# Addendum No. 1

Reference: Multiple Solar PV Facilities  
North Salt Lake Readiness Center/Cedar City Recruiting Center  
Utah National Guard  
DFCM Project No. 15329480/15330480

Subject: **Addendum No. 1**

2900 N Main St  
Spanish Fork, UT 85660

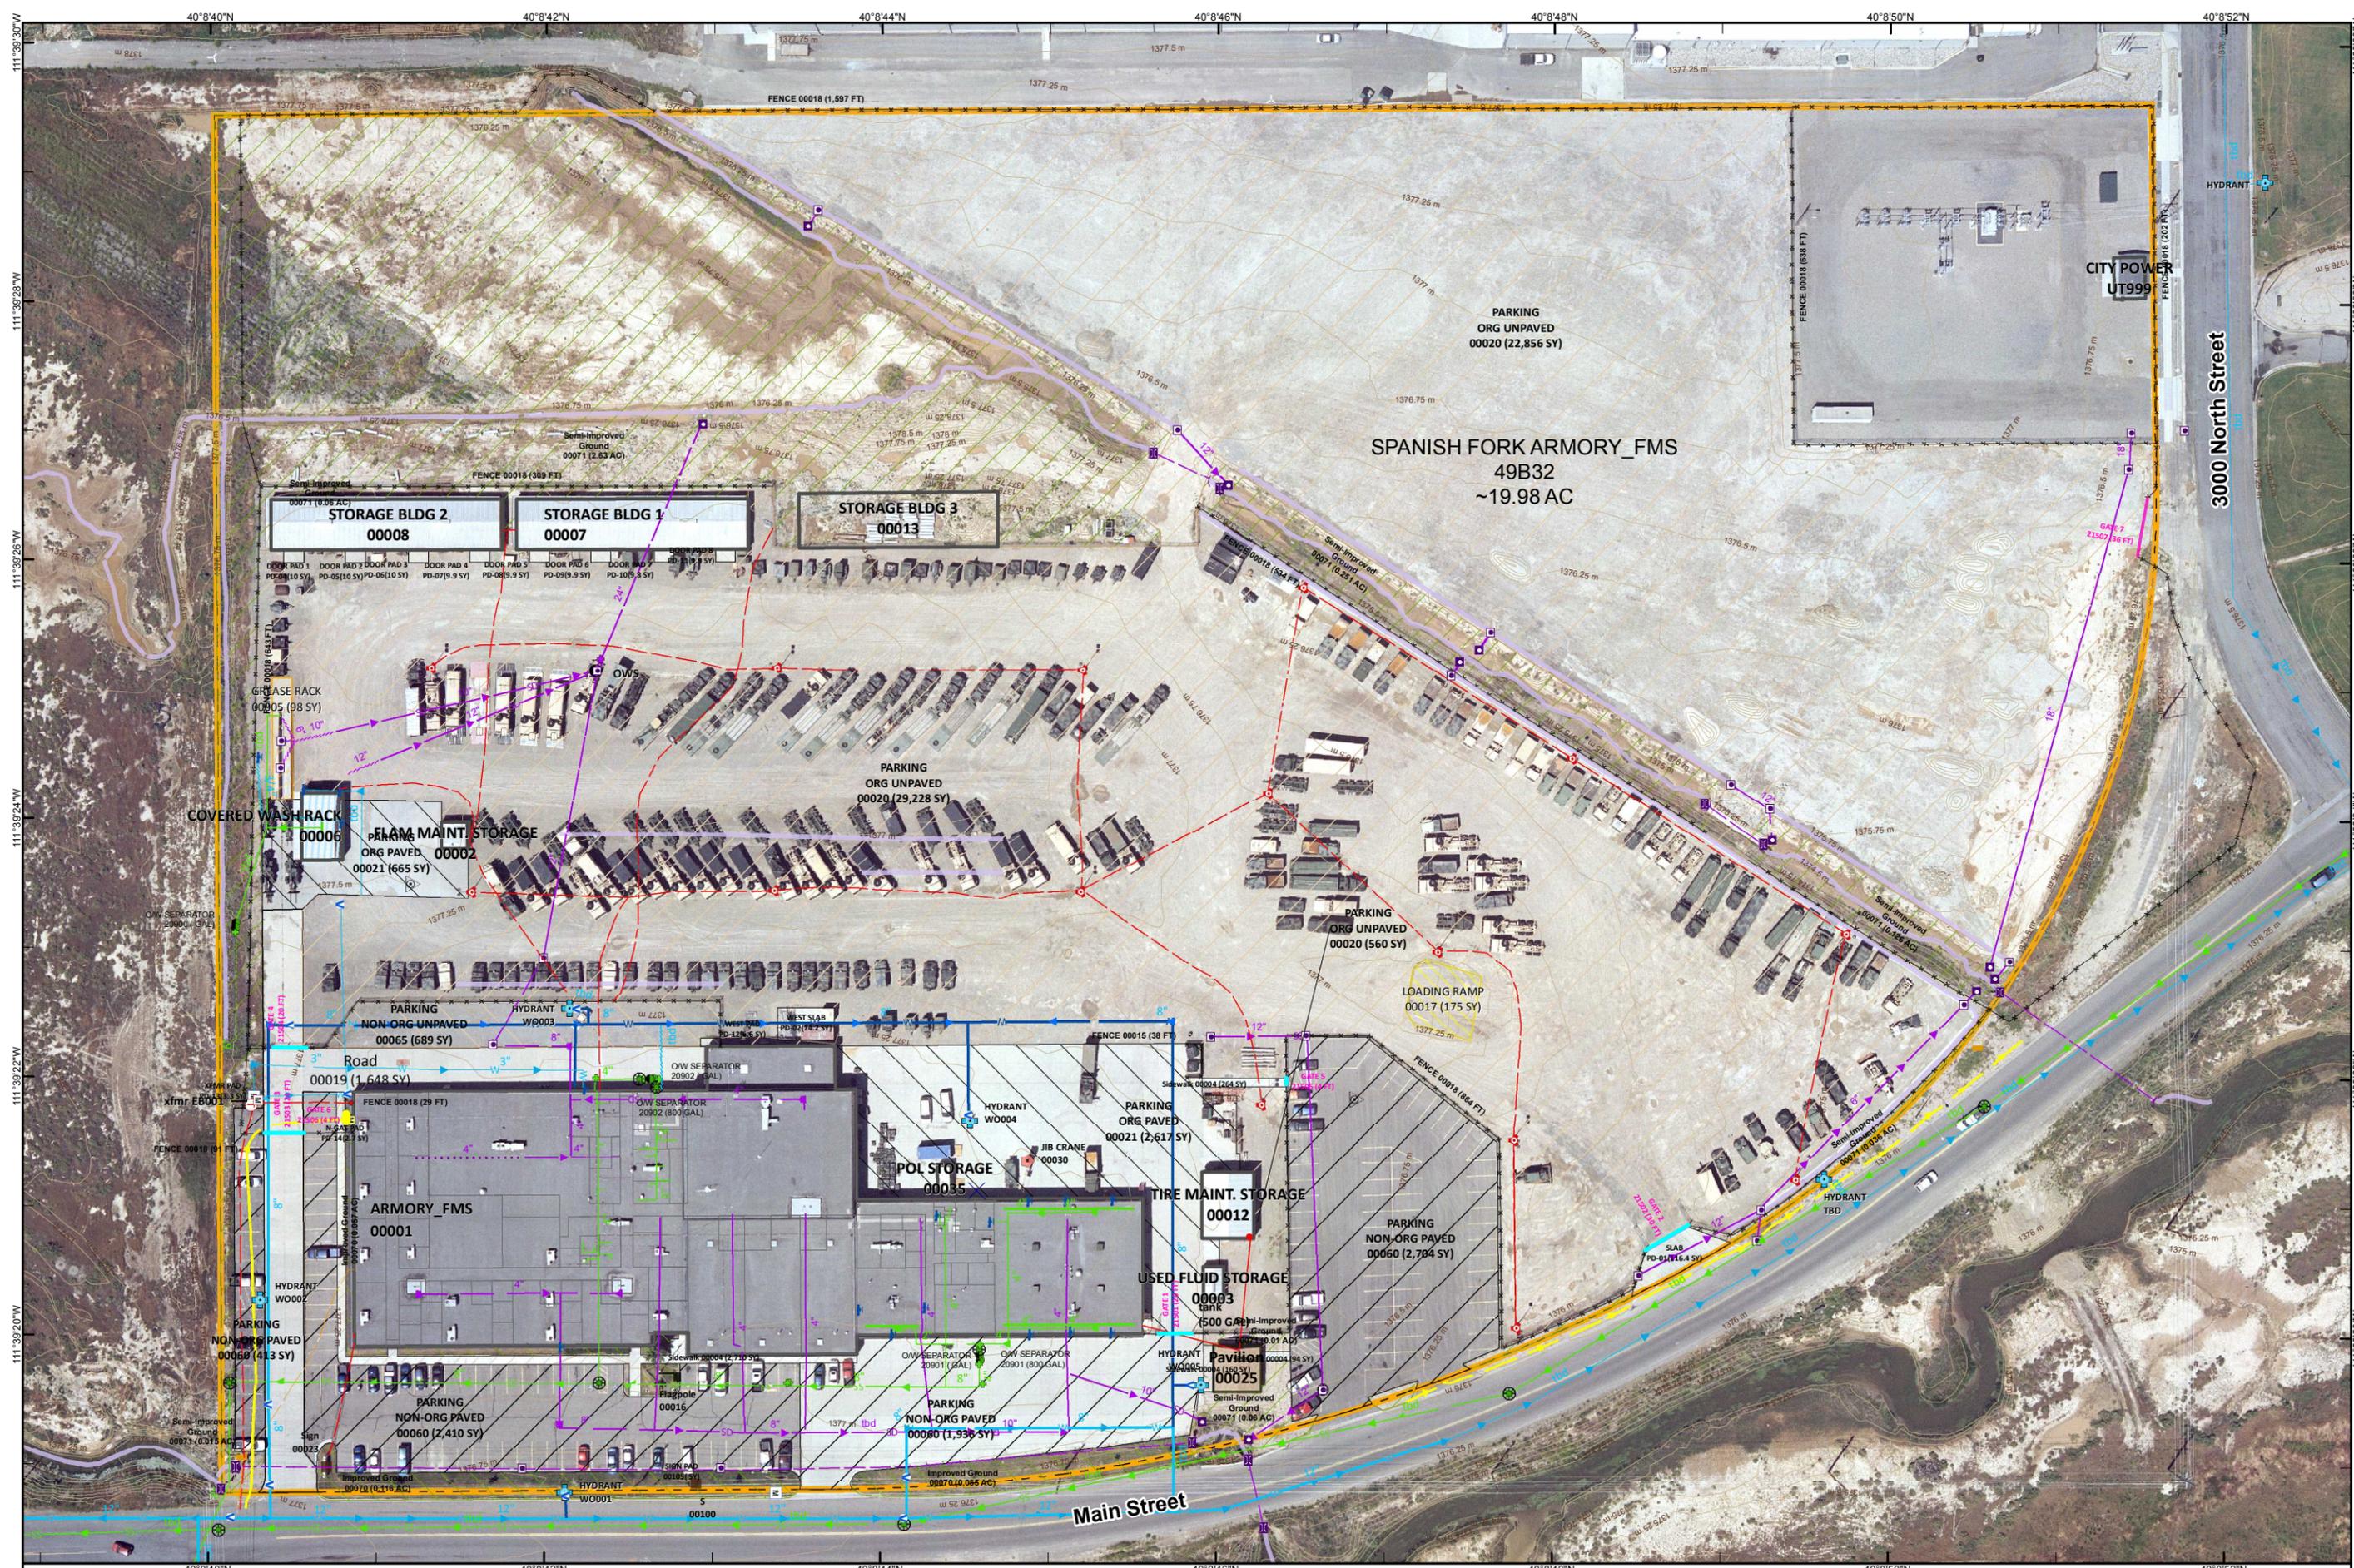
Proposed Canopy Location over Handicap Parking area on East side of facility

Approximate Size of 24 kW Parking Canopy  
E.g. 4 # panels in portrait (4 rows)  
20 modules (66 ft) length  
4x20 = 80 modules

66'x22'

**A4 ELECTRICAL SITE PLAN**

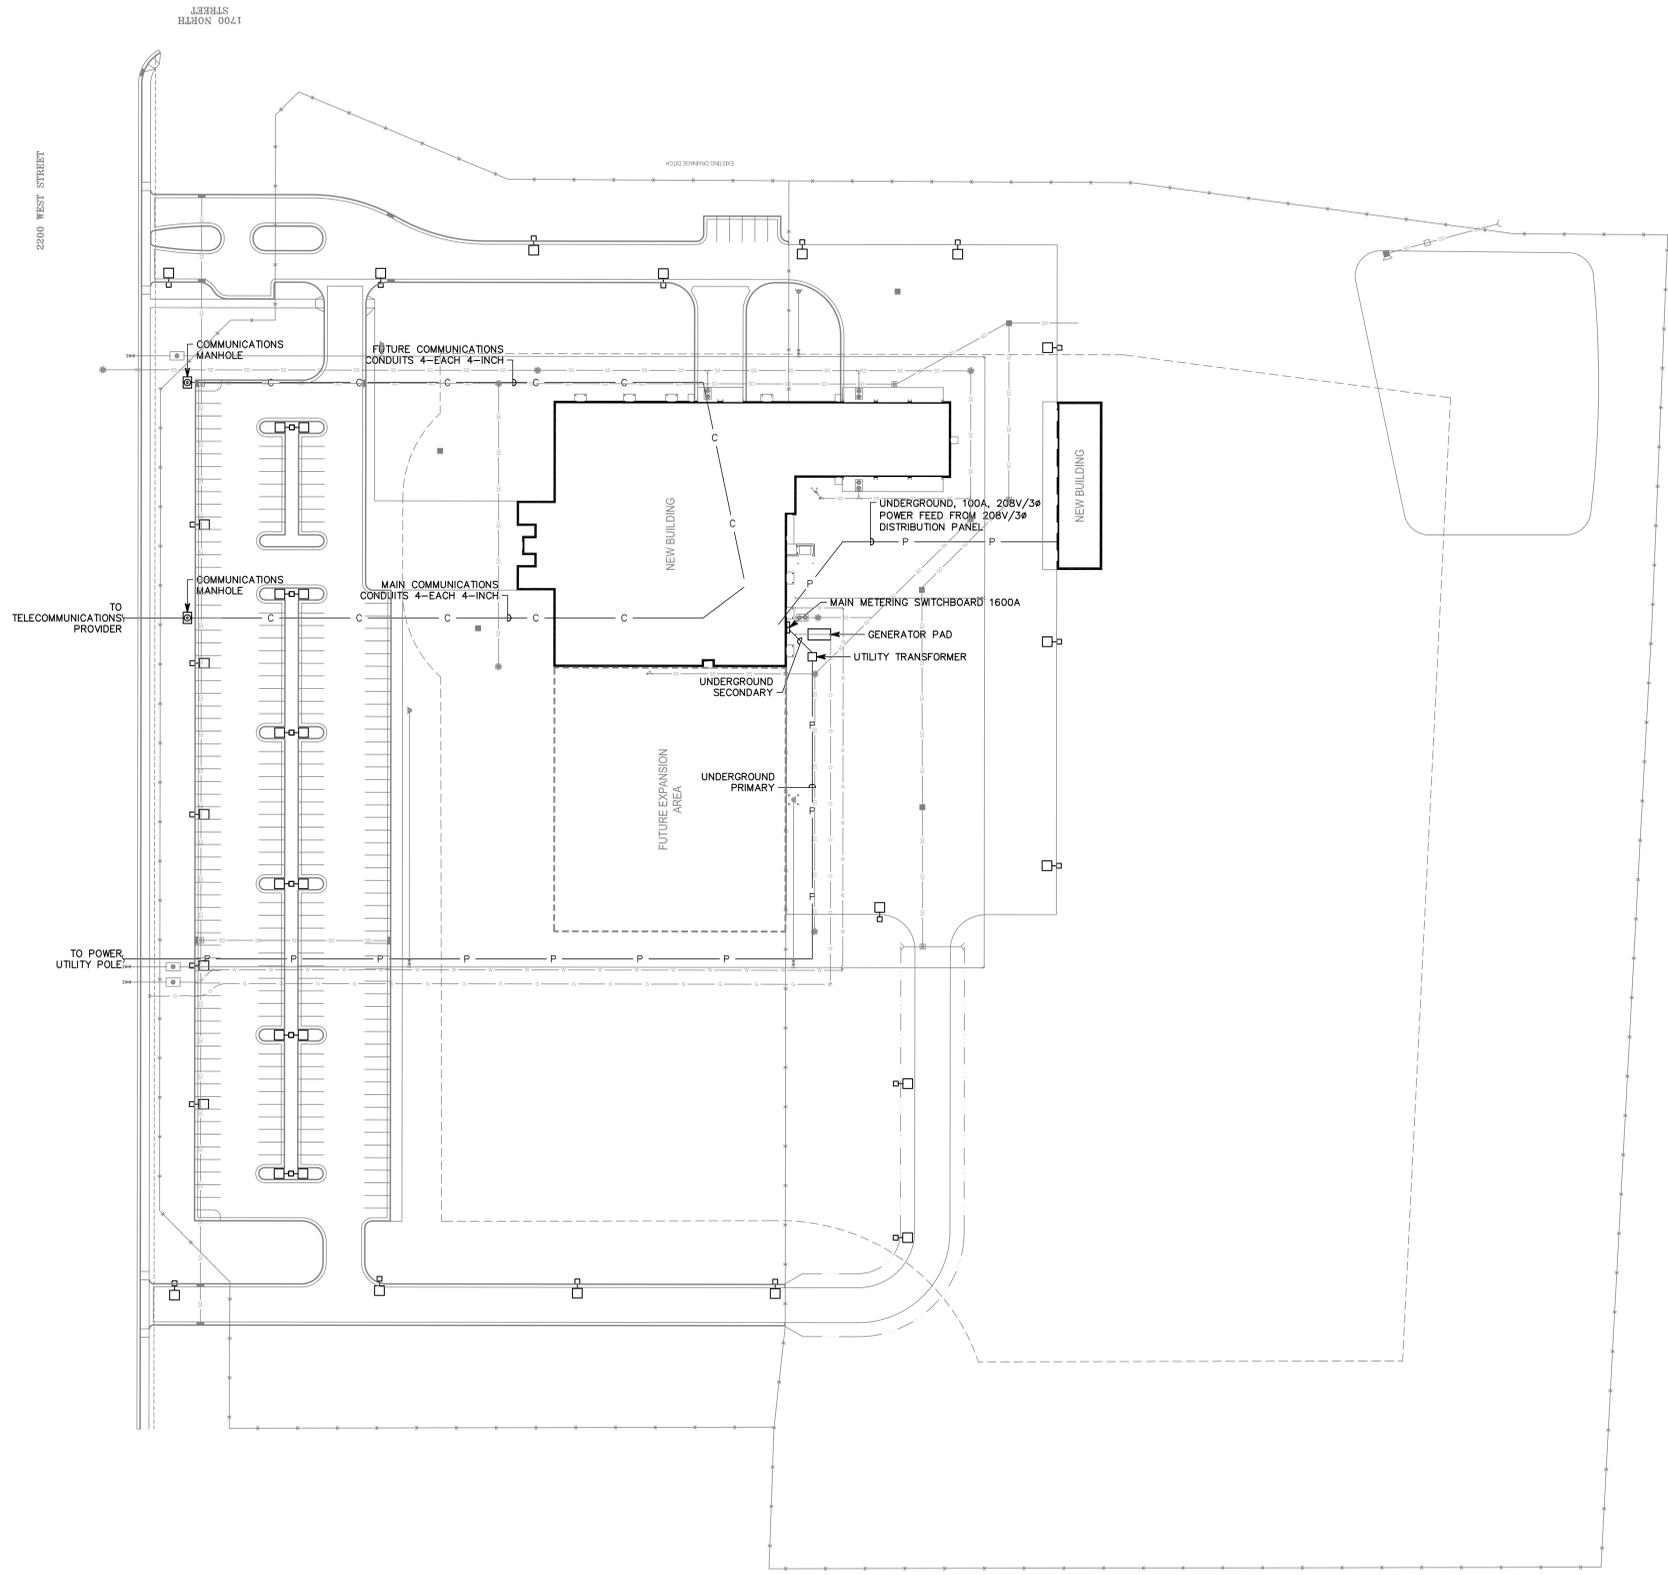
1. Given the footprint available (backside, southeast corner of the building), are the bidders authorized to assume that the Solar Canopy Structure can extend into the gravel parking lot directly to the south of the desired location?

2. Assuming we can build out in the gravel on the south, will the new parking surface need to be concrete to match existing, or is highway grade asphalt and acceptable alternative?

3. Is it preferred that the bid be prepared under the assumption that any additional square footage of canopy which will not fit in the parking area in the rear of the building, is to be constructed in the west (front of building) parking lot, as designed per the original RFP?

4. Please provide a drawing with dimensions of the concrete parking area where the canopy is desired to be built
5. Are we to assume that the loading dock ramp (gravel structure) at the back of the parking area is to remain?

UTNG is no longer considering the idea of putting canopies in the concrete area behind the facility (on the south-east side of the building). Please only bid the project as shown on the layout with canopies in the west parking lot.
